MCF5282 User's Manual Errata

This errata document describes corrections to the *MCF5282 ColdFire Microcontroller User's Manual*, order number MCF5282UM. For convenience, the addenda items are grouped by revision. Please check our website at http://www.freescale.com for the latest updates.

MCF5282UMAD
Rev. 8
01/2005

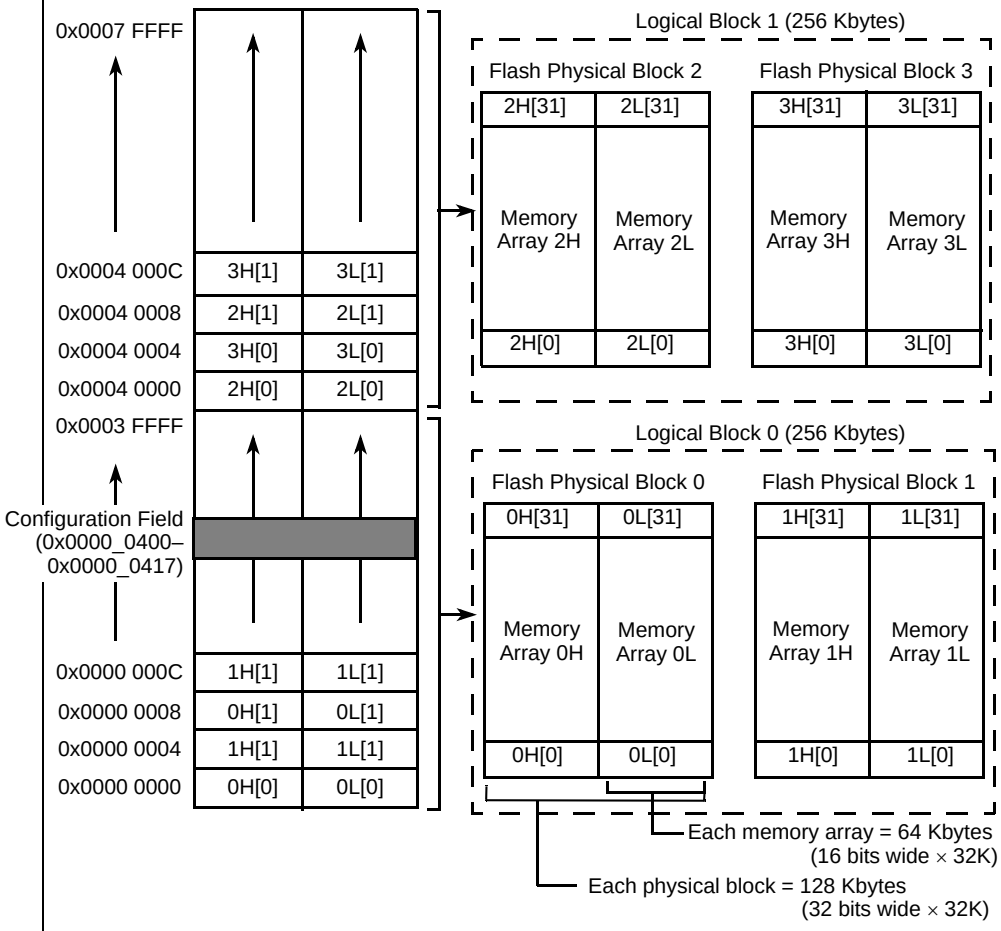
Location	Description
Figure 6-2/6-4	Replace Figure 6-2, "CFM 512K Array Memory Map," with the figure below.

Figure 33-5. SDRAM Read Cycle

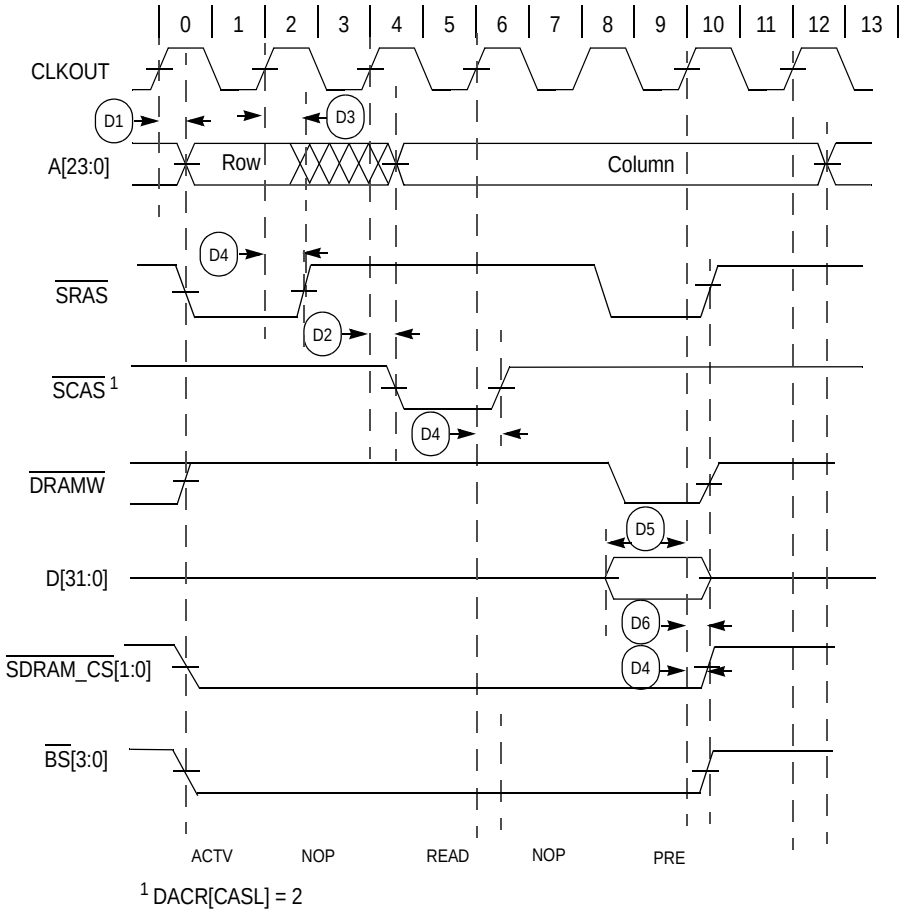
Location	Description
Figure 33-5/33-16	Replace Figure 33-5, ‘SDRAM Read Cycle’ with the figure below.
Table 14-3/14-11	Change ‘Internal Pull-Up’ column to pull-up indications in the table below.
